## ADDENDUM NO. 1

Reference: Northern Utah County Campus – Mountainland ATC  
Utah College of Applied Technology – Lehi, Utah  
DFCM Project No. 07039260

## Addendum No. 1

Project: Northern Utah County Building  
Address: 1550 North Freedom Boulevard  
City, State: Provo, Utah

**E3 CONTROL JOINTS**

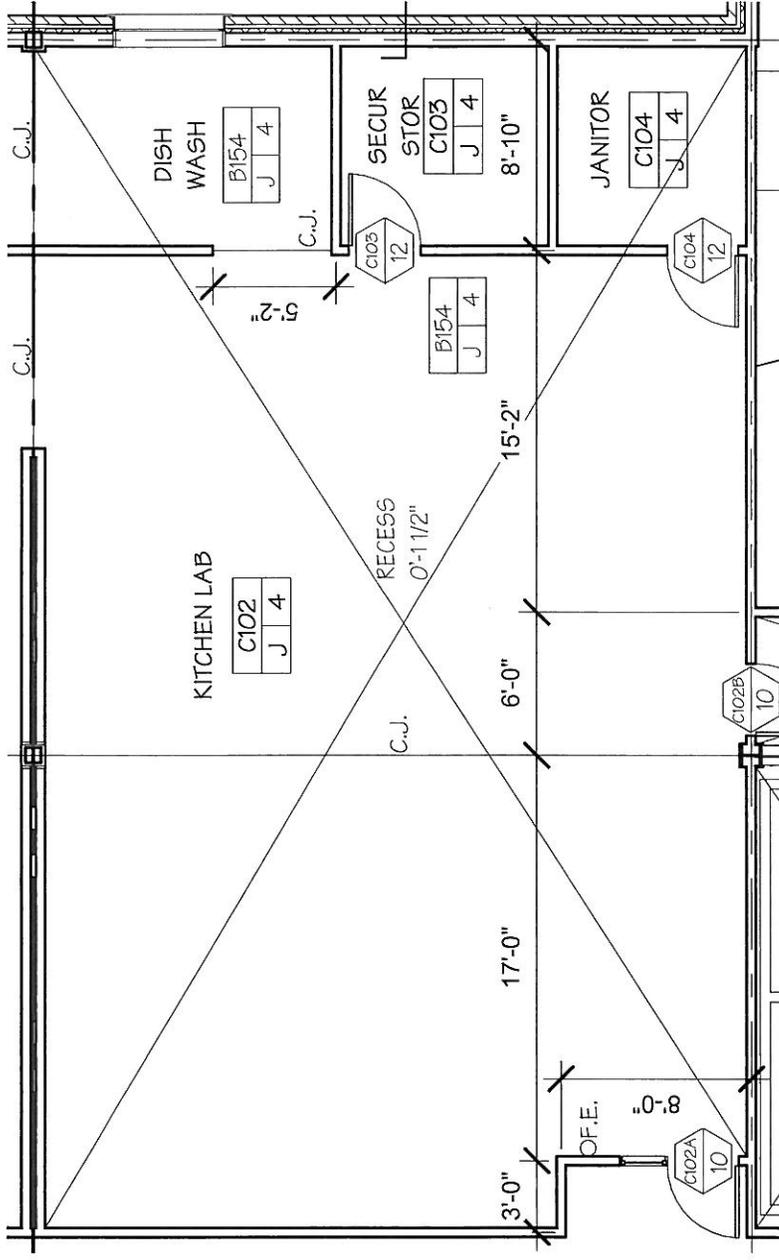
<b>DRAWING ITEMS</b>		
1-14	AE101B	Detail B4: See revised drawing for location of CONTROL JOINTS.
1-15	AE101C	Detail E3: See revised drawing for location of CONTROL JOINTS.
1-16	AE103A	Revise detail reference A1/AE313 between grids I-H and 4-4.2 to read A1/AE311.
1-17	AE103A	Revise detail reference A6/AE313 between grids I.2-I and 2-3 to read A1/AE311.
1-18	AE103A 01	Revise detail reference A1/AE313 between grids I-H and 4-4.2 to read A1/AE311.
1-19	AE103A 01	Revise detail reference A6/AE313 between grids I.2-I and 2-3 to read A1/AE311.
1-20	AE103A 01	See attached drawing for location on new fin wall.
1-21	AE201	Clarification: Precast concrete band above the natural stone base is continuous around the building.
1-22	AE502	Detail D5: See revised drawing of the RAISED FLOOR DETAIL.
1-23	AE502	Detail D4: See revised drawing of the CURTAIN WALL DETAIL.
1-24	AE502	Detail C1: See revised drawing of the SLIDING GLASS DOOR DETAIL.

**A2** SLIDING GLASS DOOR DETAIL

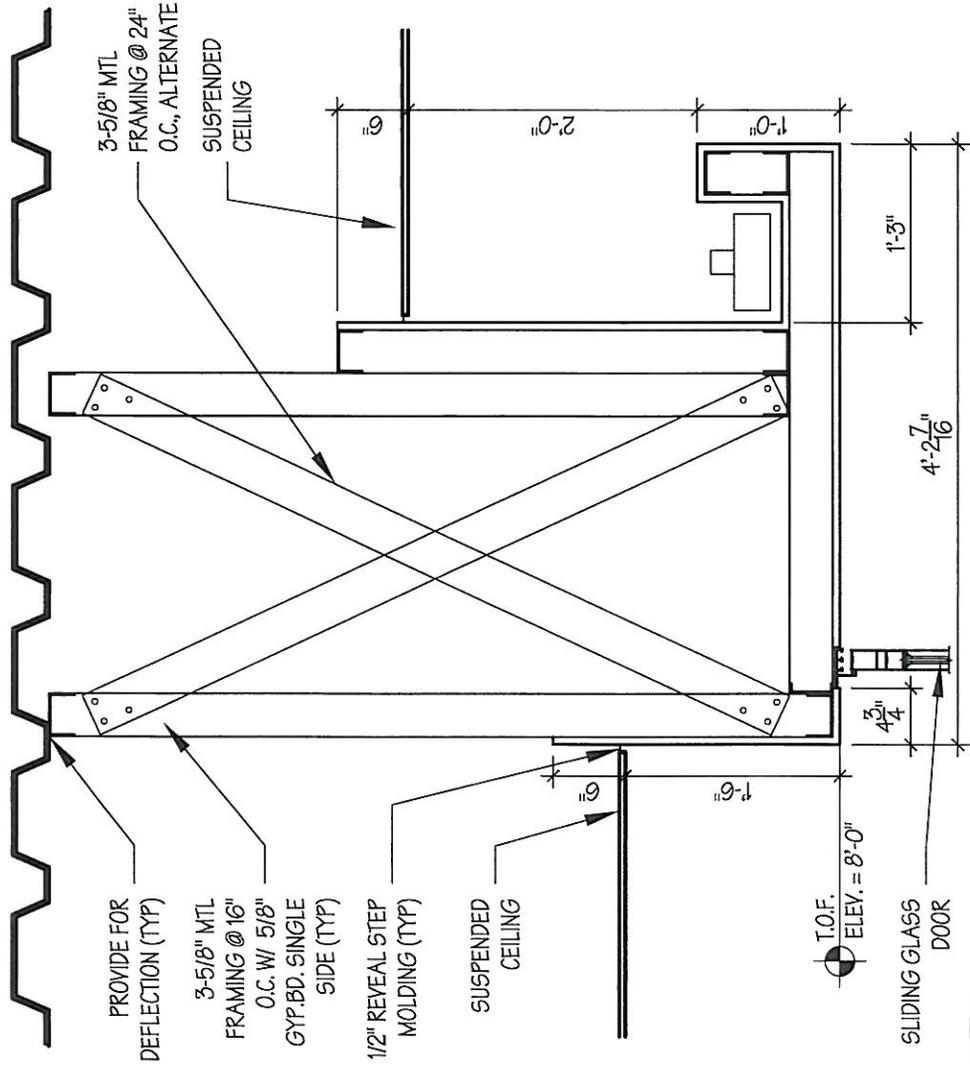
1-25	AE503	Detail A2: See revised drawing of the SLIDING GLASS DOOR DETAIL.

**ADD#1 SALON DESK SECTION**

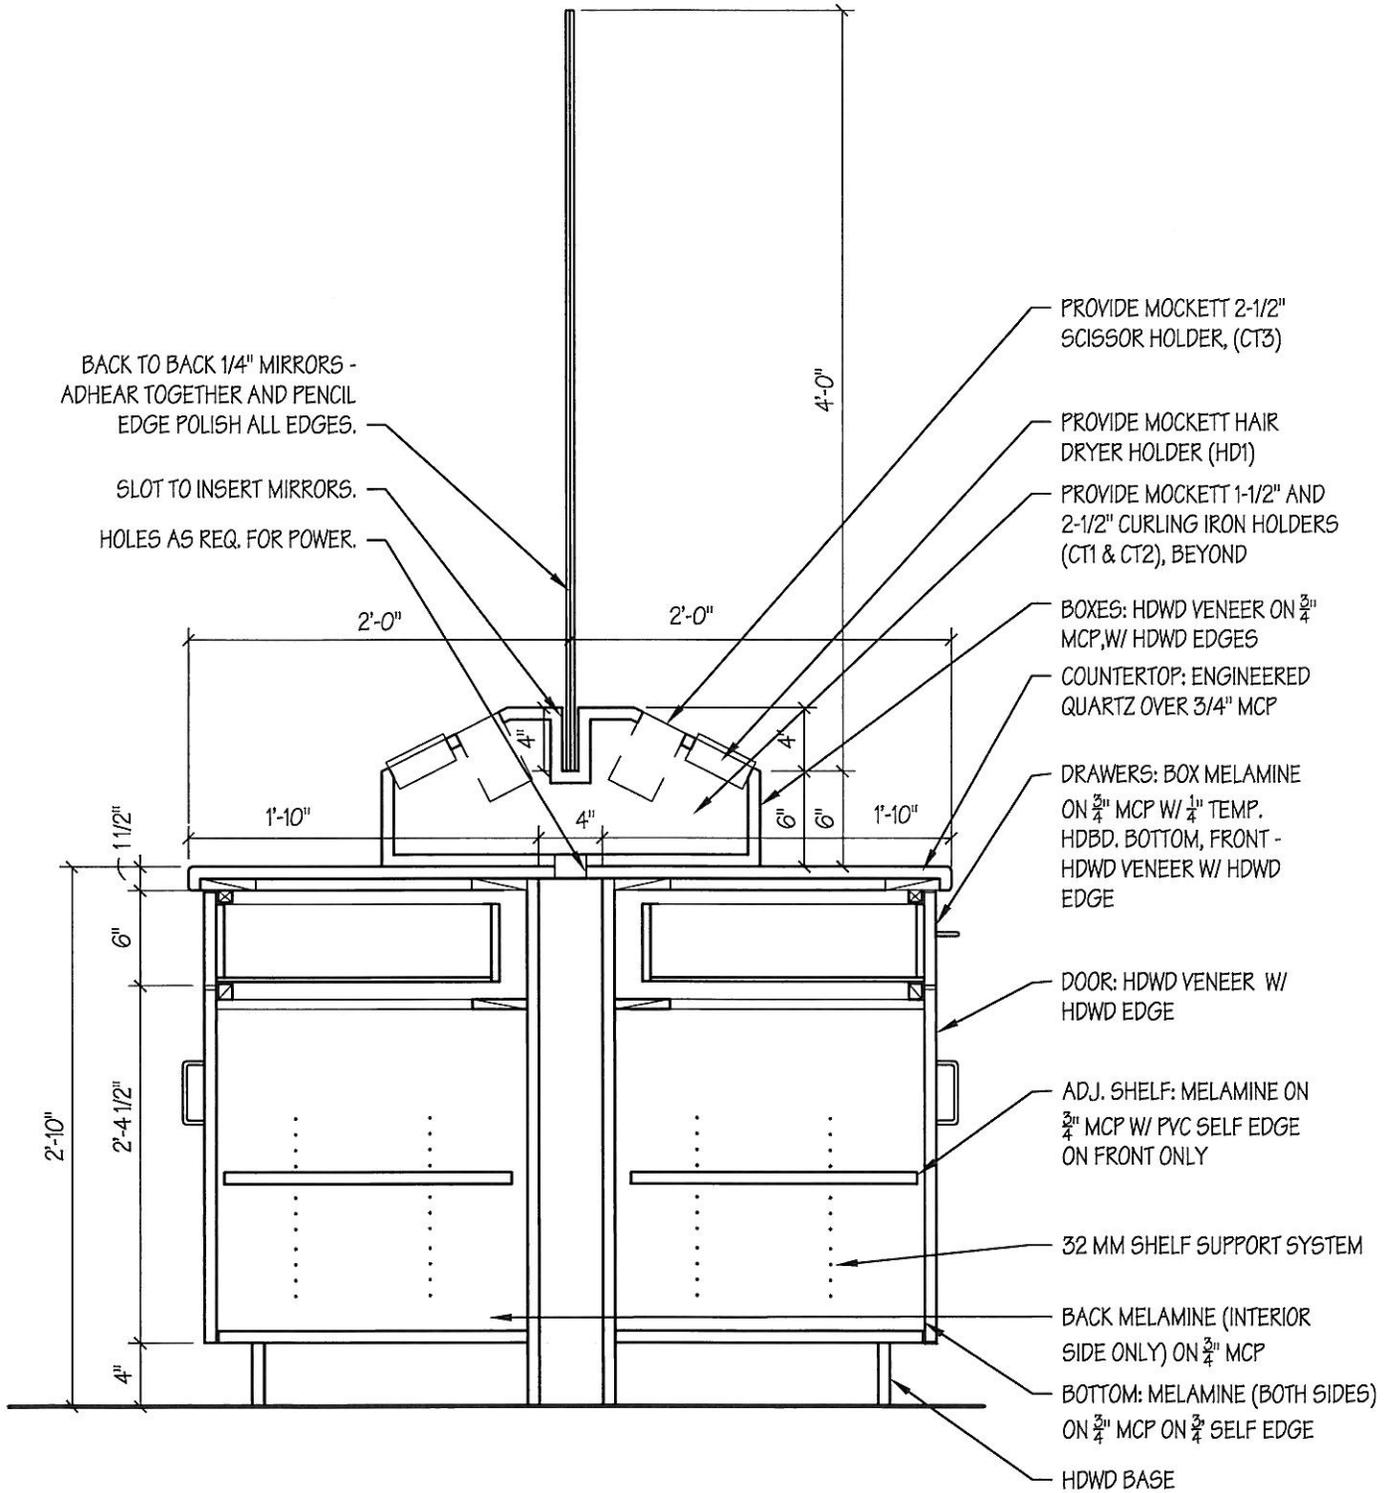
Item No.	Section or Sheet No.	Description
1-26	AE702	Detail A1: See revised drawing of the SALON DESK SECTION @ CABINETS.
1-27	AE702	Detail C1: See revised drawing of the SALON DESK SECTION @ COUNTER.

REF SHEET: SB101C  
**ADD1-SSD-01**

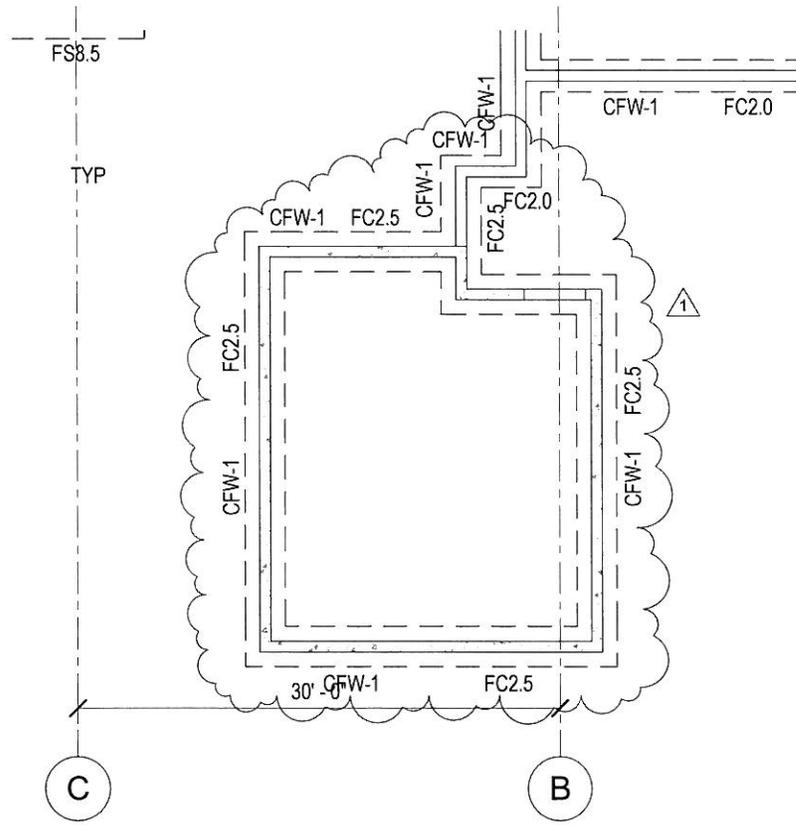
1. See Supplemental drawing ADD1-SSD-1 for revised mechanical enclosure.

**ADD #1 MSD01**  
**MATC NORTHERN UTAH COUNTY BUILDING**

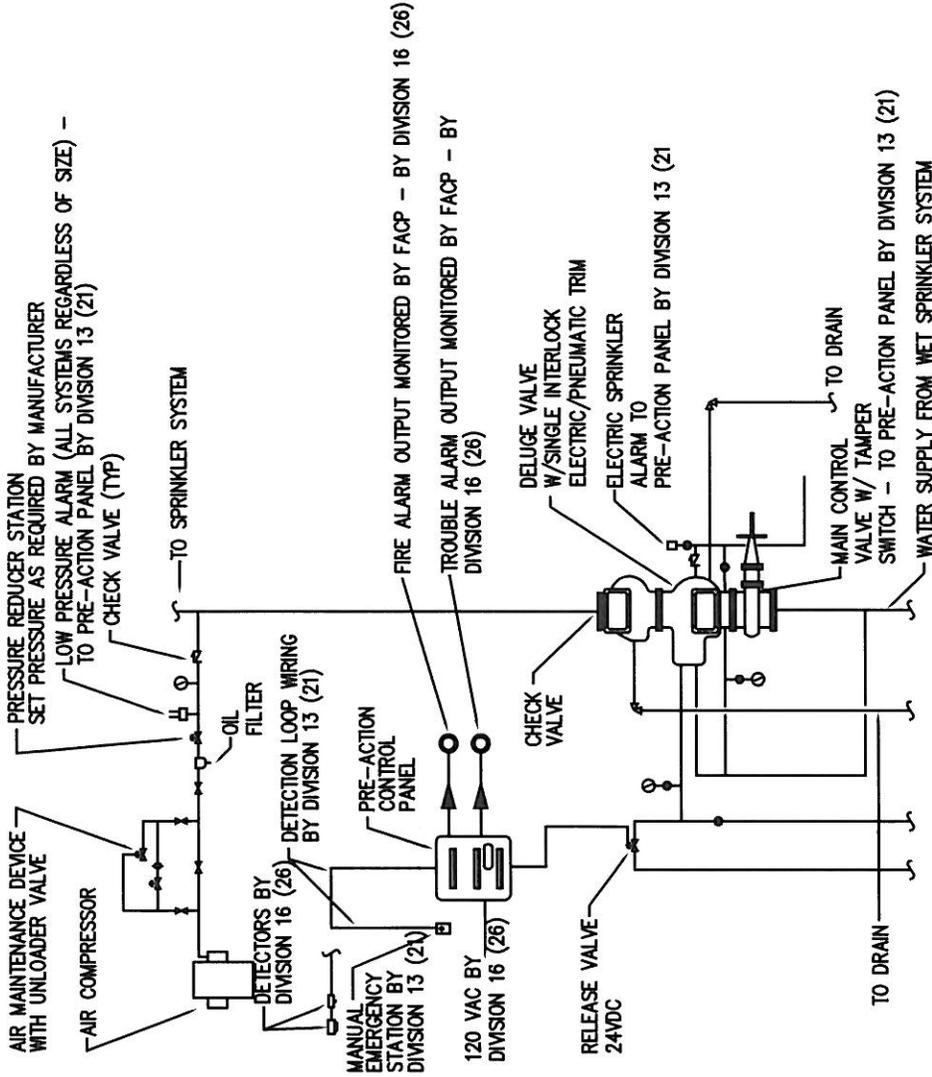
1. Water Cooled Chiller Schedule: Replace the York Chiller with a Carrier Chiller. See MSD-01 for new chiller schedule.
2. Air Handler Schedule: Change the length of the air handler from 49 inches to 518 inches.
3. Air Handler Schedule: Minimum number of fans for supply and return will be 8 each.
4. Air Handler Schedule: See drawing for location of column in mechanical room. Custom build for demounts to be at location of column.
